# Technical Service Bulletin

GROUP	NUMBER			
	Body	20-BD-016H-1			
	DATE	MODEL(S)			
	December, 2020	Santa Fe (TMa) Palisade (LX2)			
Ū

### SECOND ROW SEAT TRACK NOISE REPAIR

# This TSB supersedes 20-BD-016H by updating the applicable vehicles to Santa Fe (TMa) vehicles built before 8/1/2019.

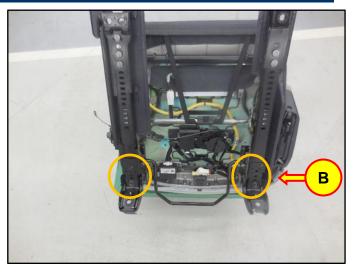
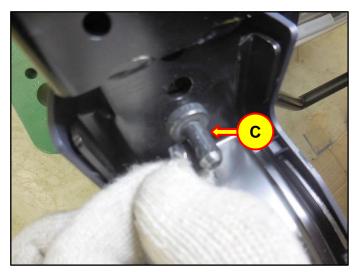
3. Place the rear seat on a workbench, and locate the track location pins (B).

4. Use a utility knife to cut the existing location pin tubes (C).

5. Remove and discard both location pin tubes.

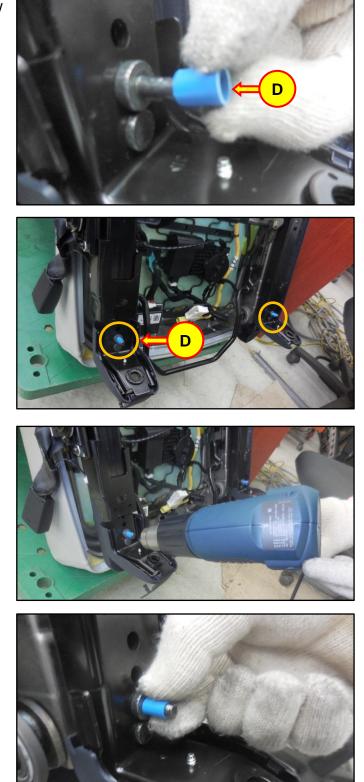
6. Replace both location pin tubes with the new tubes (K).

7. Use a heat shrink gun to heat the location pin tubes.

Heat all sides evenly.

After heating, the tube should not rotate.
